DESIGN REVIEW BOARD MAY 21, 2021

1. 09:10 - 09:50 DRB200033 First Baptist of Alpharetta 44 Academy
review exterior
2. 09:50 - 10:10 DRB210027 Gracious Home 10 Cumming St
review exterior and signage
3. 10:10 - 10:20 DRB210024 Warm Waves Coffee 52 North Main St
review signage
4. 10 minute break
5. 10:30 - 10:40 DRB210029 Starbucks 11740 Haynes Bridge
review signage
6. 10:40 - 11:05 DRB210026 6390 North Point Pkwy
review landscape plan
7. 11:05 - 11:25 DRB210023 NLB Services 221 Roswell St
review exterior painting
8. 11:25 - 12:15 Break
9. 12:15 - 13:00 DRB210025 Windward Promenade 875 North Main St
review painting the buildings
10. 13:00 - 14:00 DRB210028 Lazy Dog 10800 Haynes Bridge Rd
new construction review elevations, materials, landscaping

SITE LINE STUDY

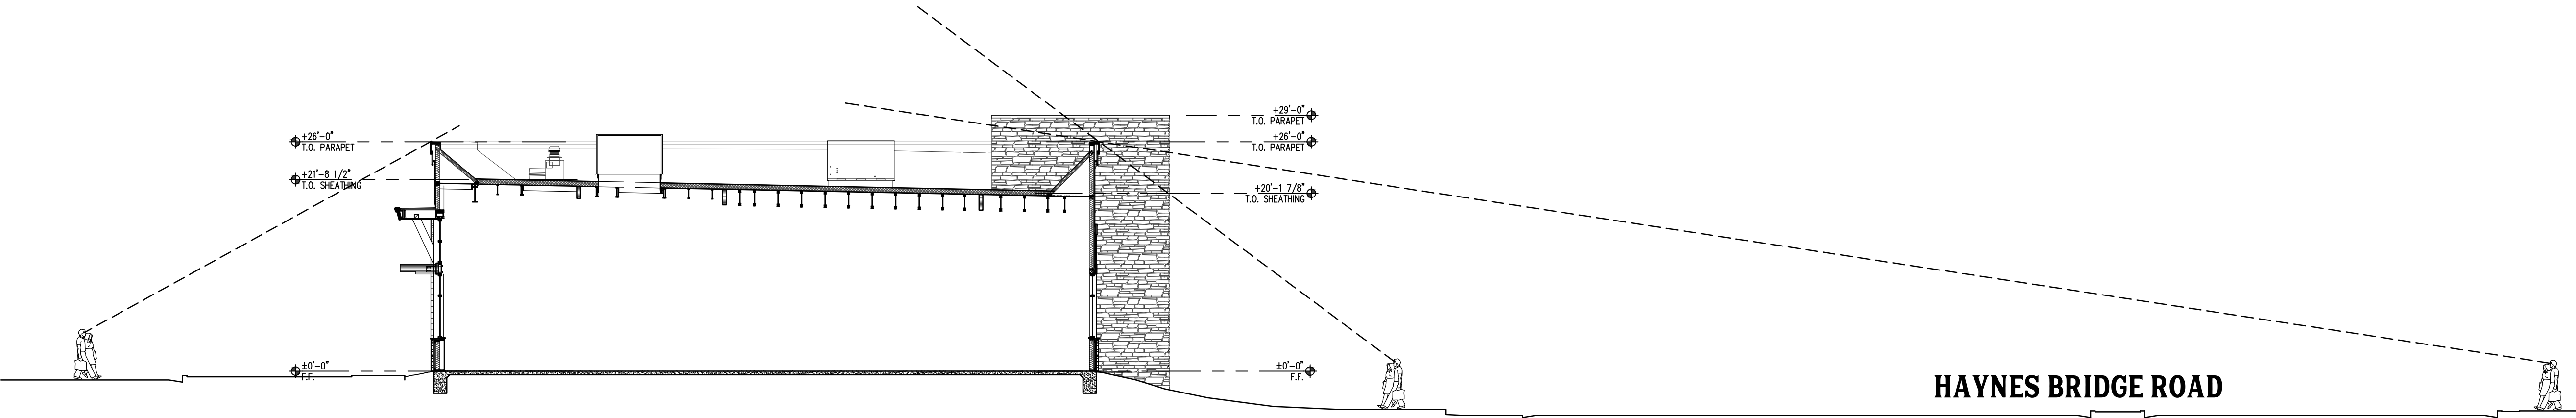
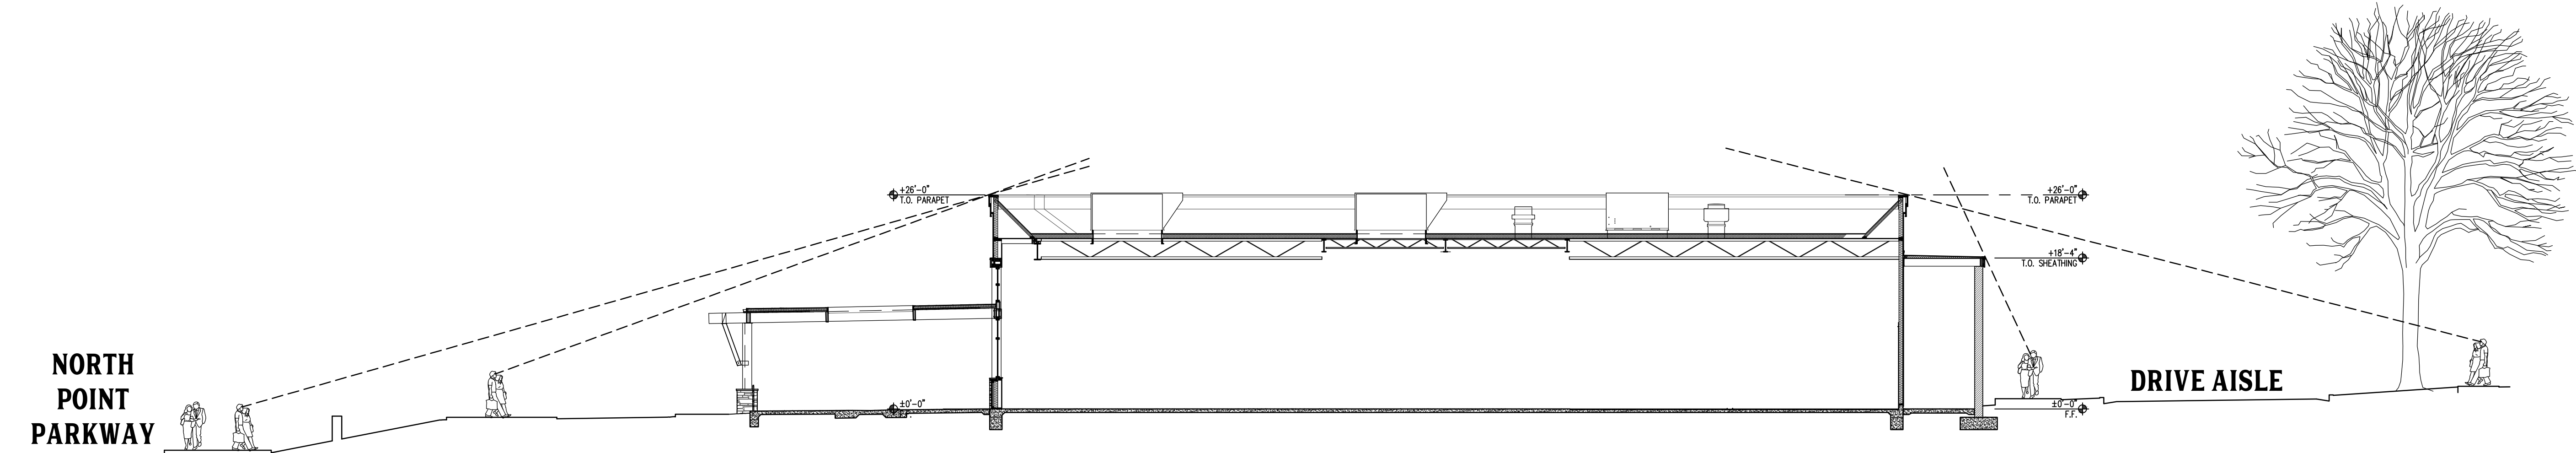
9. Site line study from several areas along the R/W showing RTU's is required – See sheet DD4.3 & DD4.3A
10. maximum 50% stucco on any elevation (not including parapet, maybe) – See sheet DD4.0 & DD4.1 for stucco percentages

DD4.4

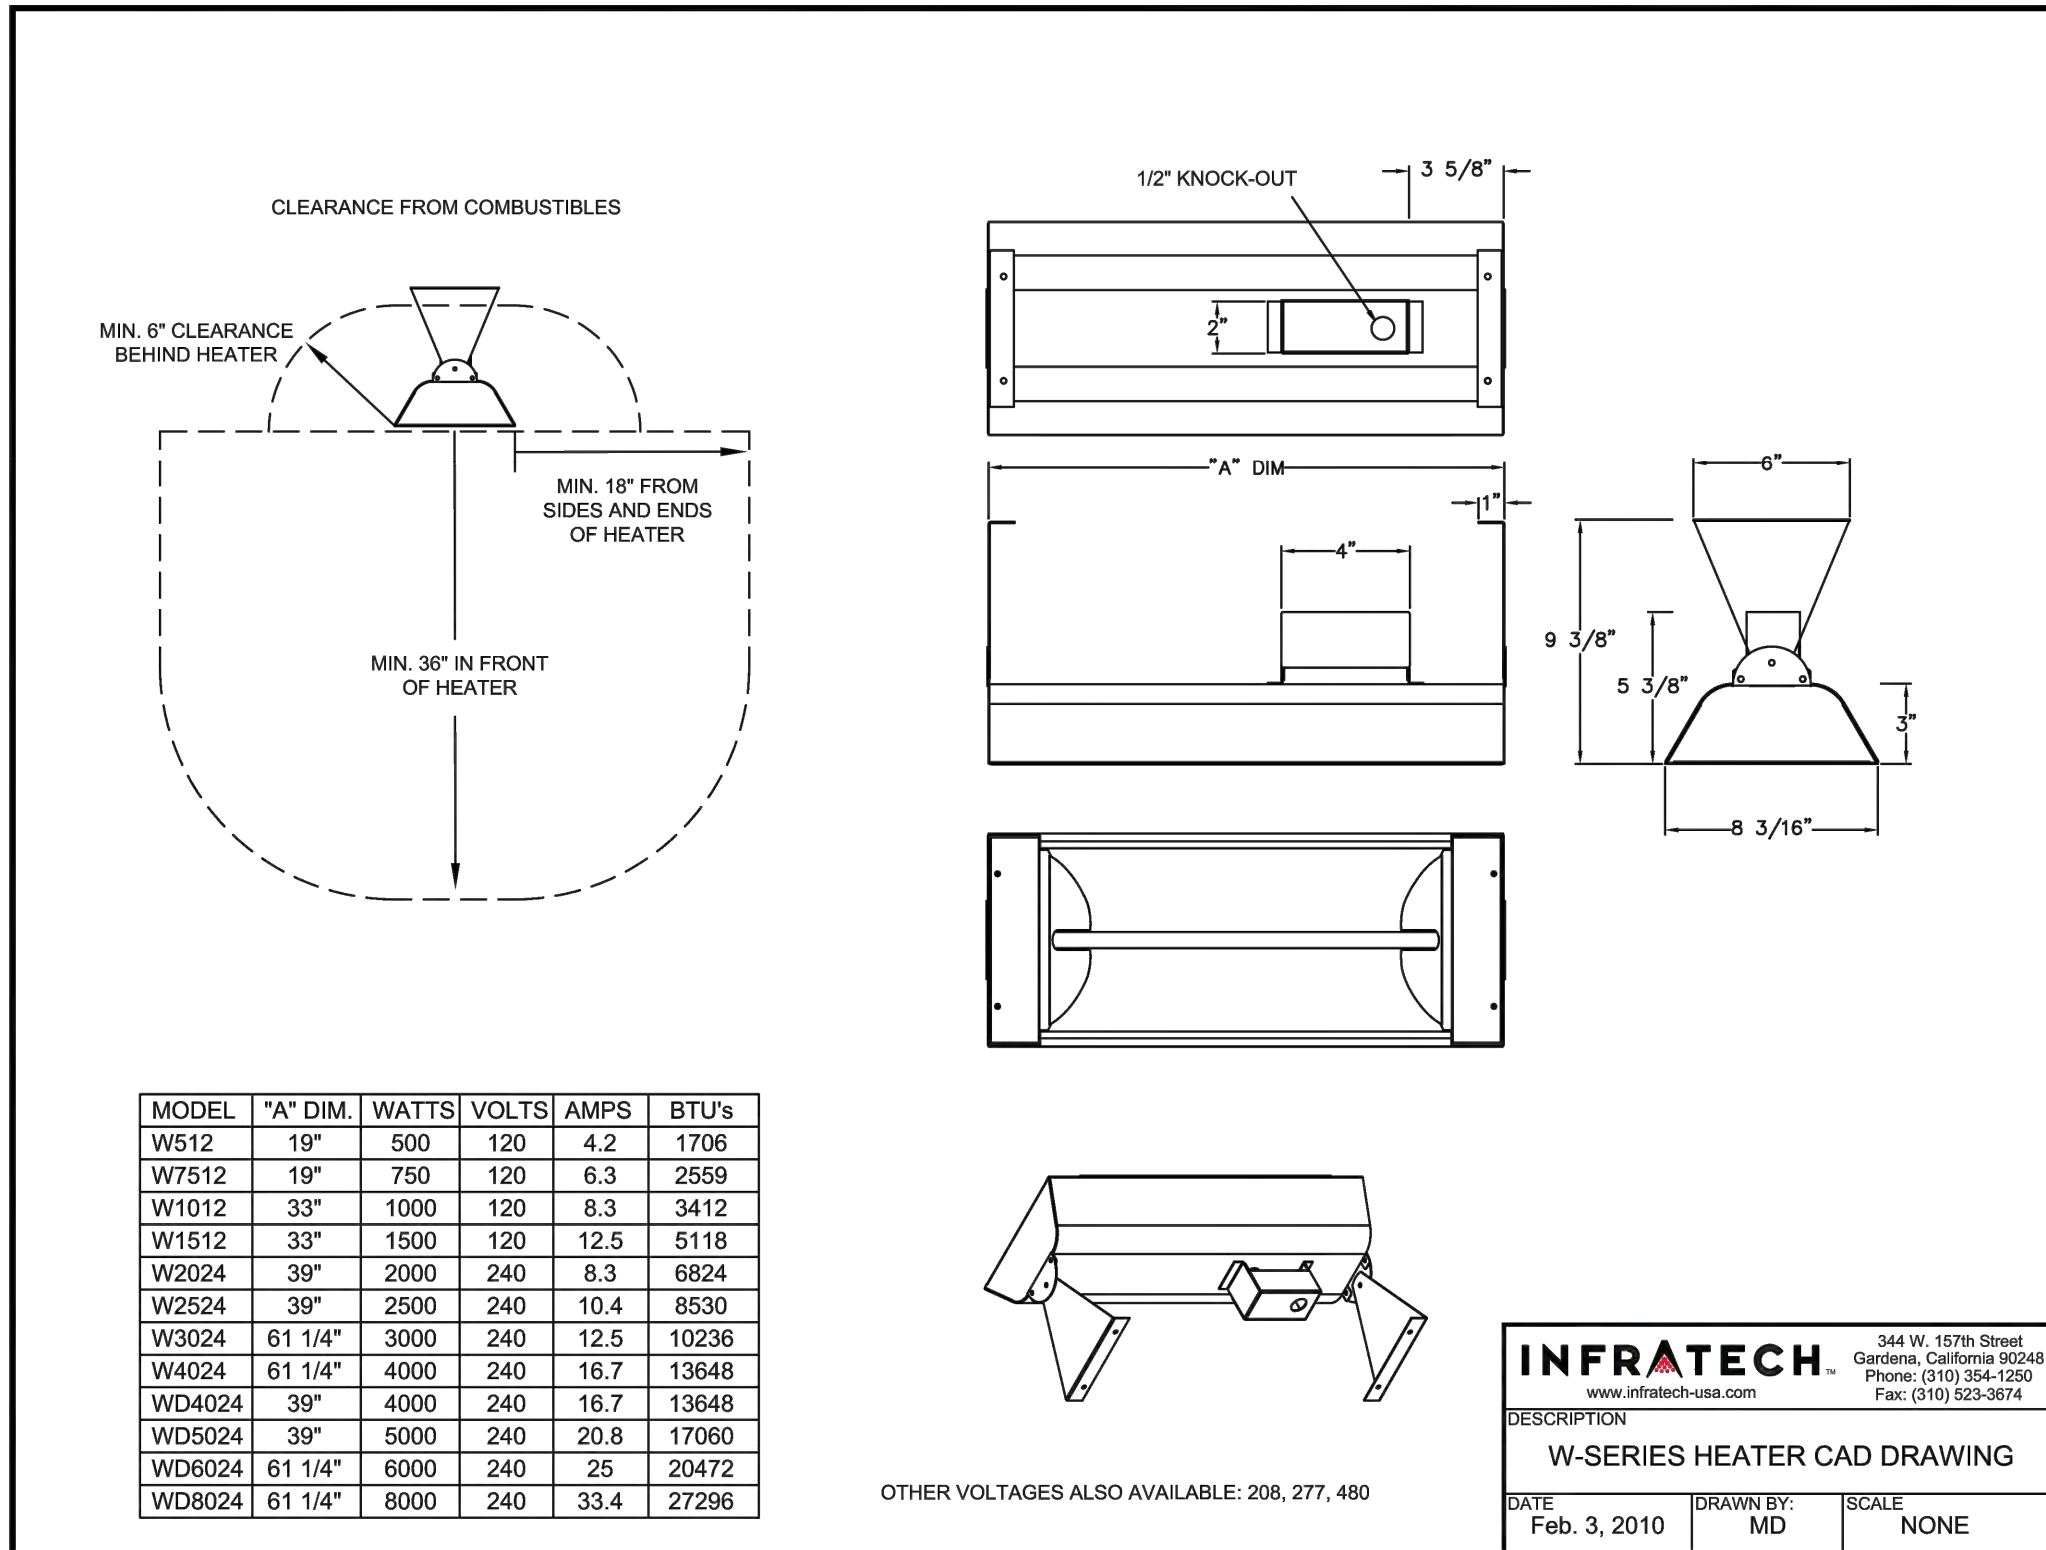
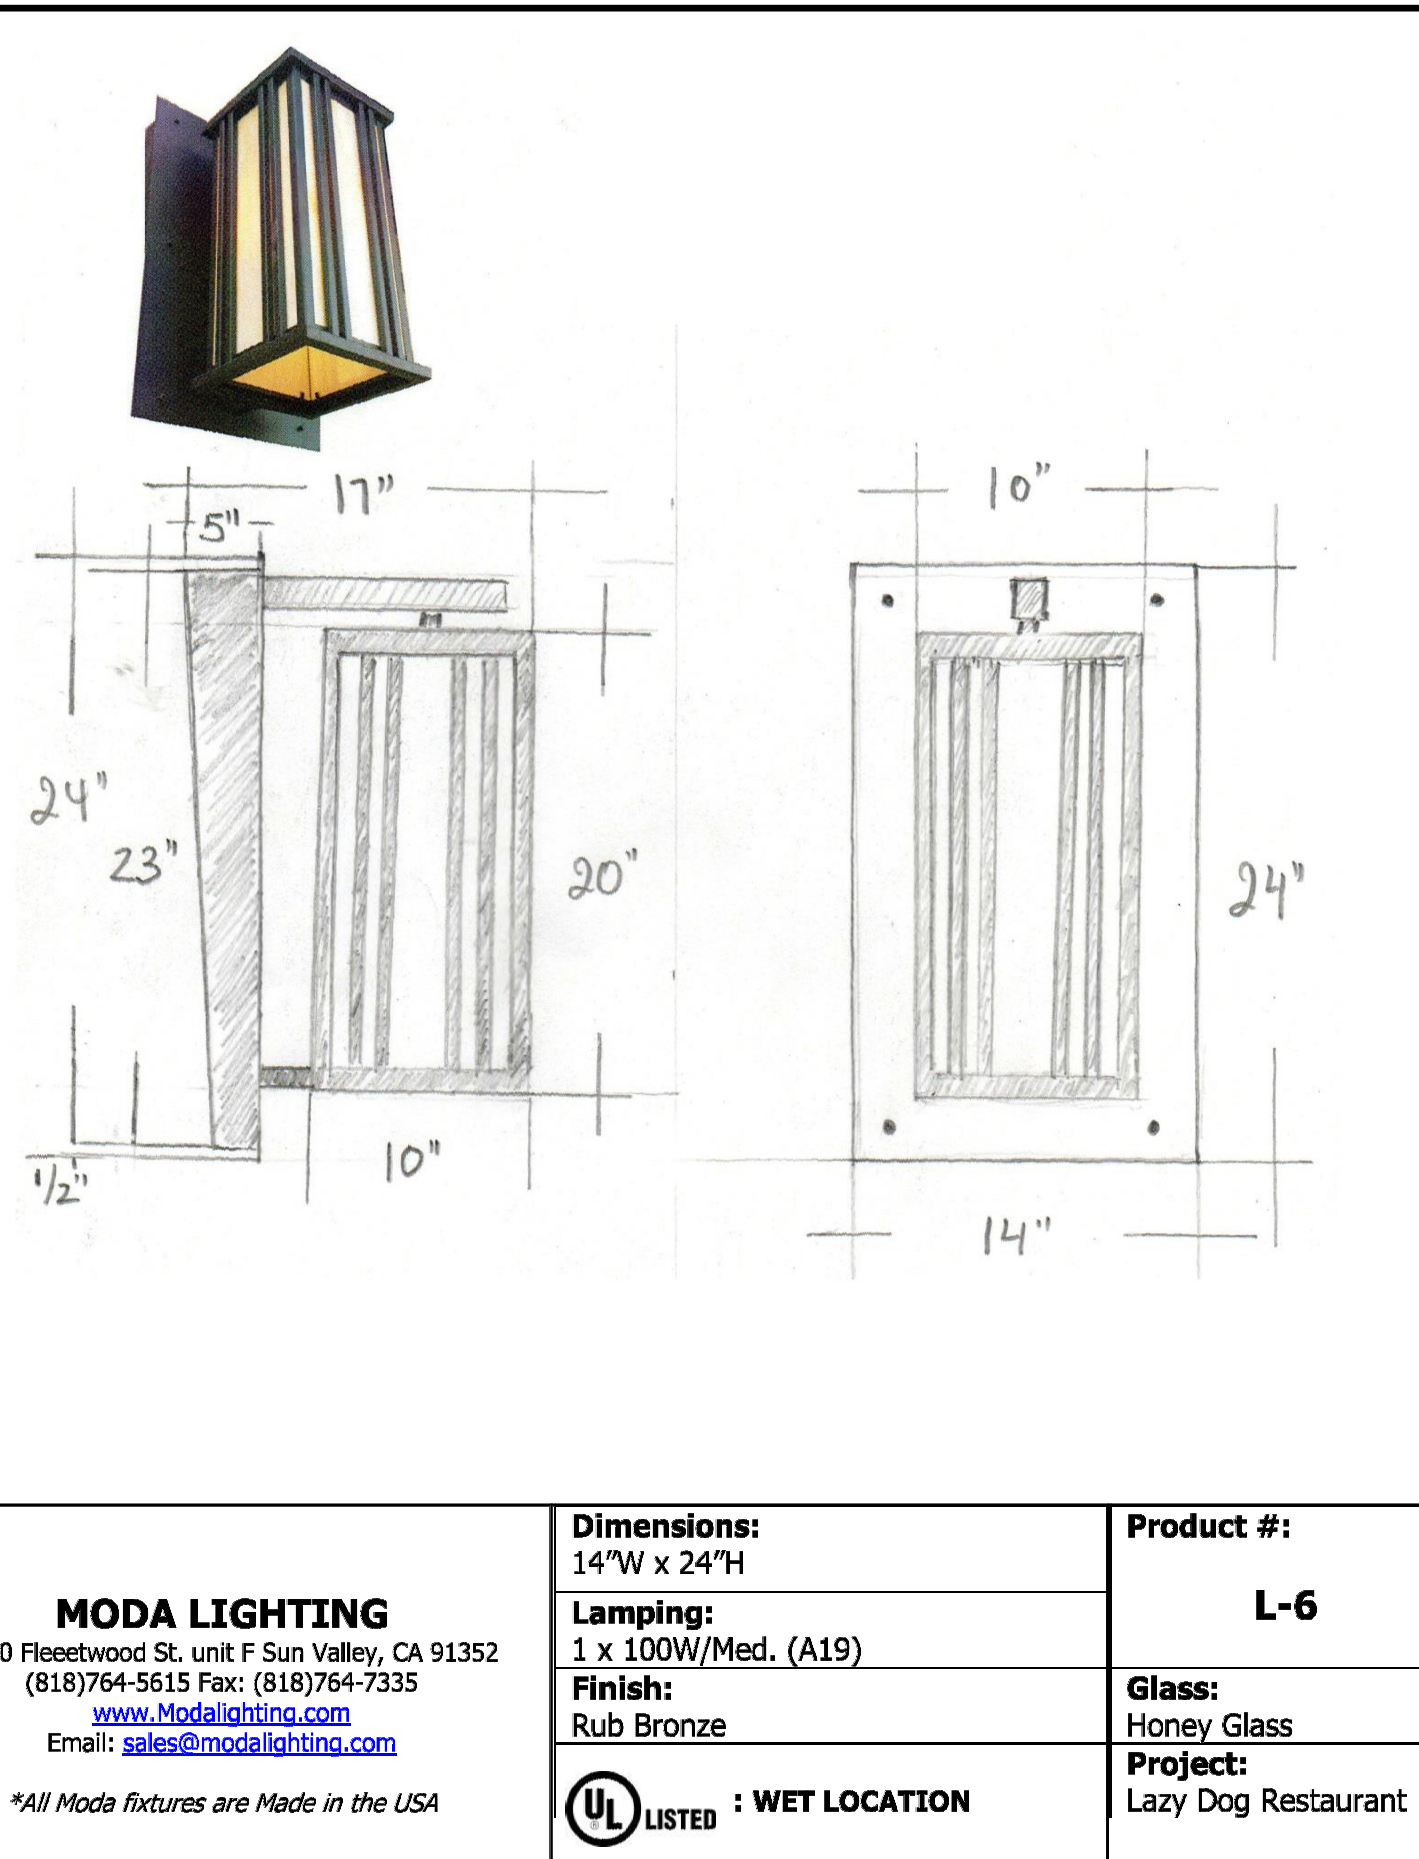
6. Any lights, fans, heaters, etc on the patios must be shown and detailed – See sheet DD4.4
7. Exterior light fixtures not shown in detail – See sheet DD4.4 for cut sheets
